Project Address : 4311 7th Avenue NE
Seattle, WA 98105

Meeting Type : Administrative Design Review

SDCI Project # : 3030684-LU

Development Objectives

Level 6-8 - MUP- Dep. 1/16" = 1'-0"

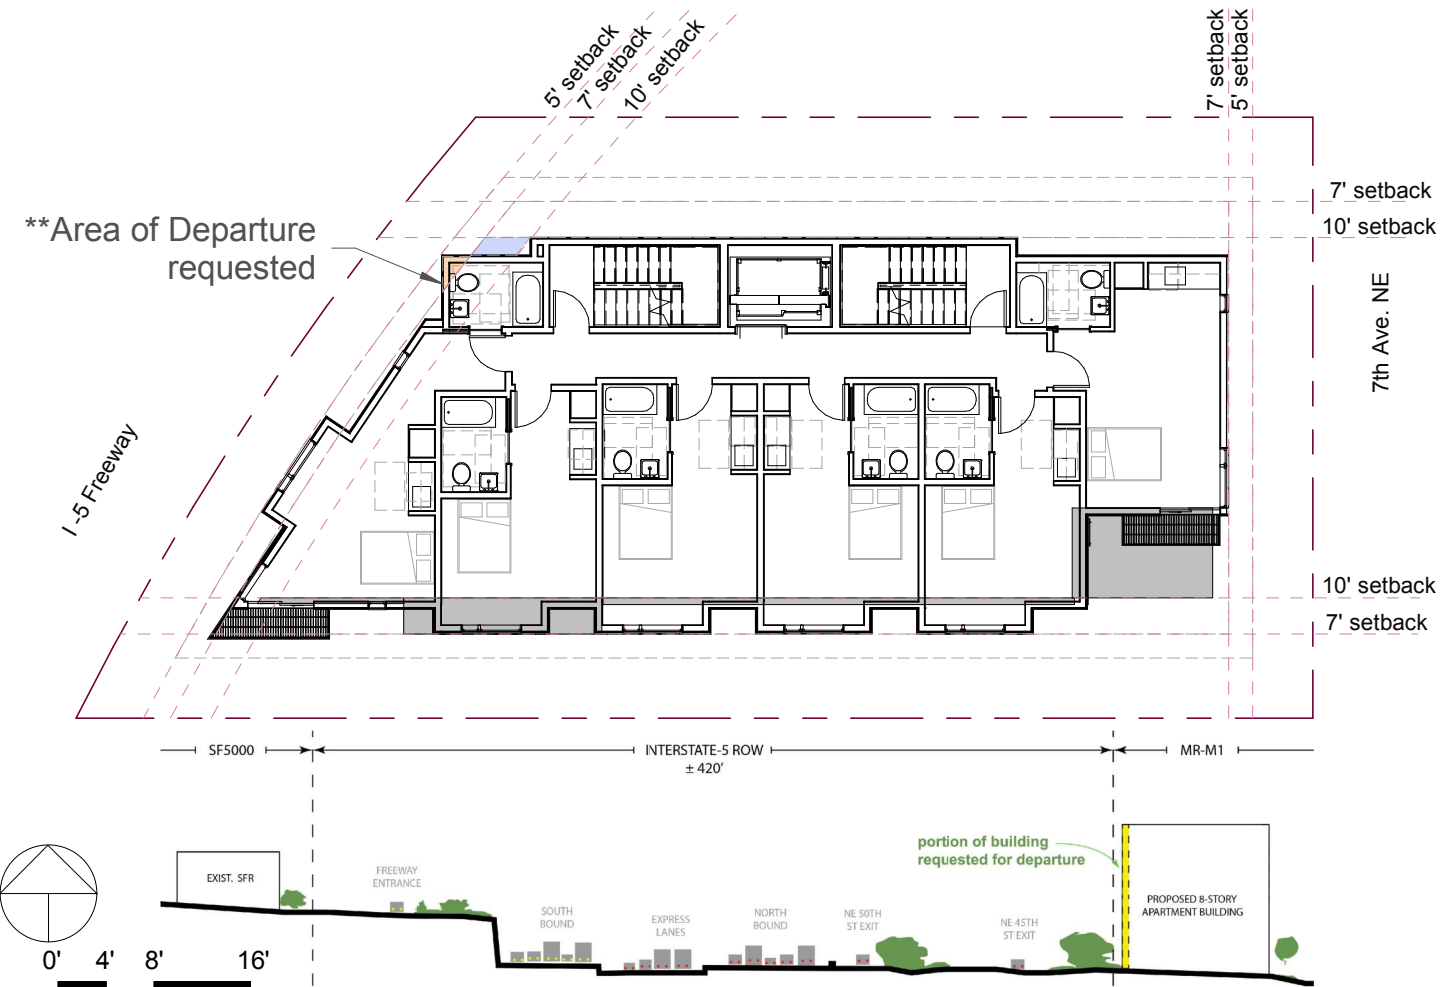
1. Rear setback reduction (23.45.518, Table B): The Code requires an average of 7 ft setback with a 5 ft minimum above 42 ft and a 10 ft average setback with 7 ft minimum below. The applicant proposes that the setback be reduced to 5 ft below 42 ft and 5 ft above with a 7 ft average.

We are asking for a departure to reduce the western side setback above and below 42 feet. And for the set back below 42 feet to be reduced from 7 foot average / 5 foot minimum to 5 feet. At 42 feet and above asking to reduce from 10 foot average / 7 foot minimum to 7 foot average / 5 foot minimum. This departure allows the upper four stories of the building to essentially shift to the west without the loss of floor area, increasing the setback along 7th Ave NE above 42 feet. The larger setback on 7th helps to reduce the bulk of the building by stepping back from the street creating a four story podium which better responds to the scale of the adjacent buildings. In general we feel that a stepped setback can be more effective at responding to the neighborhood context along the street than at the i5 corridor which has no pedestrian experience.
